FLOOR PLAN & PLUMBING REVISIONS

CHATEAU 10 SUNSET

UNIT 302 FLOOR PLAN

A103B

UNIT 302 – THOWFEEK

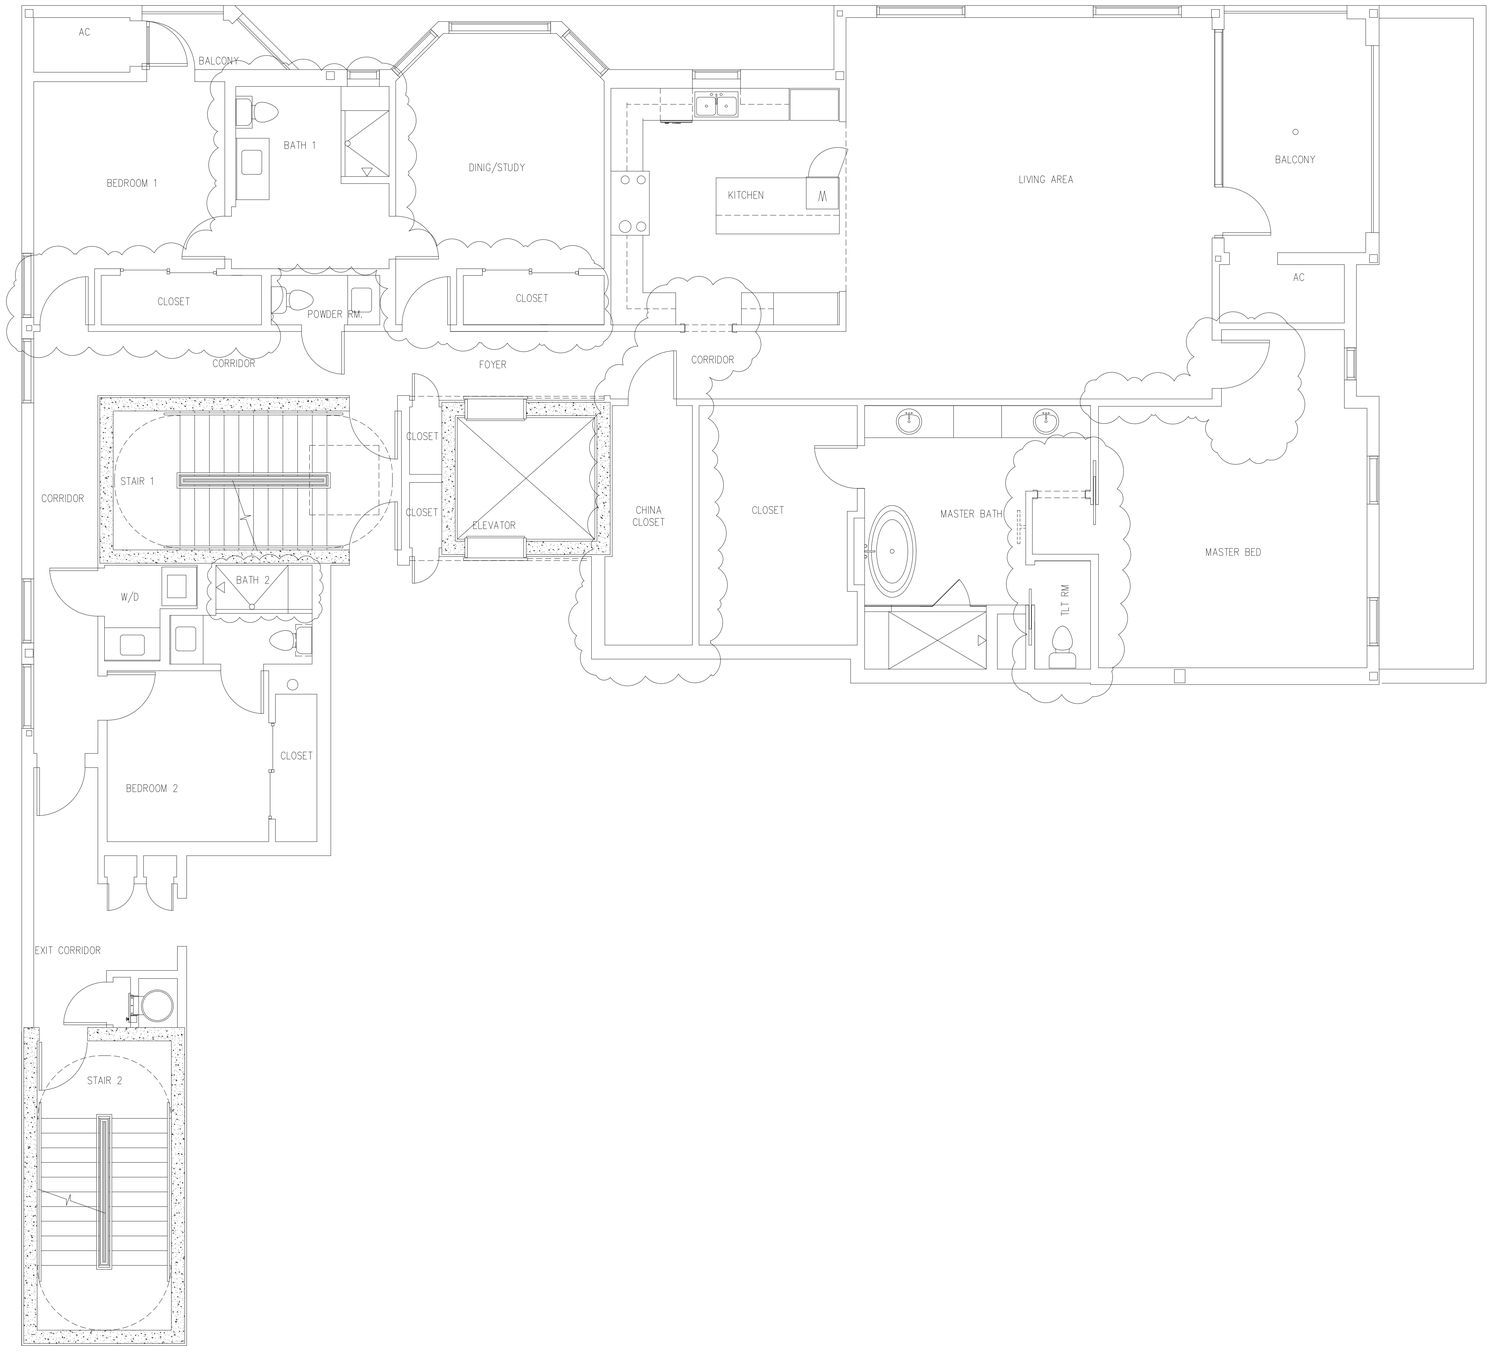
1. ADD CHINA CLOSET.

2. FRAME DOOR OPENING AT CLOSET FOR A 3-0" X 8'-0" DOOR.

1. REVISE LAYOUT – REFER TO DRAWINGS.

2. FRAME DOOR OPENING INTO ROOM FOR A 3'-0"X 8'-0" DOOR.

3. ADD CLOSET AND FRAME DOOR OPENING FOR A PAIR OF 3'-0"X 8'-0" BYPASS DOORS.

4. ADD DOOR OPENING ON W WALL FOR A 2'-8" X 8'-0" DOOR.

1. ADD 3'-0" X 8'-0" CASE OPENING INTO KITCHEN ON N. WALL.

1. RELOCATE BEDROOM DOOR.

2. ADD CLOSET AND FRAME DOOR OPENING FOR A PAIR OF 3'-0"X 8'-0" BYPASS DOORS.

3. ADD DOOR OPENING ON E WALL FOR A 2'-8" X 8'-0" DOOR.

1. EXPAND BATHROOM BY MOVING N WALL.

2. RELOCATE TOILET AND VANITY.

3. FRAME DOOR OPENING INTO BATHROOM FOR A 2'-7" X 8'-0" POCKET DOOR.

1. ADD 3'-0" X 8'-0" CASE OPENING INTO ADDED HALLWAY OFF OF MASTER BEDROOM.

1. RELOCATE BEDROOM DOOR.

2. ALIGN S WALL.

1. ADD VESTIBULE AND 3'-0" X 8'-0" CASE OPENING.

2. ADD FRAME OPENING FOR A 3'-0" X 8'-0" POCKET DOOR INTO BATHROOM IN LIEU OF STANDARD DOORS.

3. REVISE FRAMING FOR W/C AND RELOCATE TOILET TO OPPOSITE WALL.

1. ADD SHOWER IN LIEU OF TUB/SHOWER.
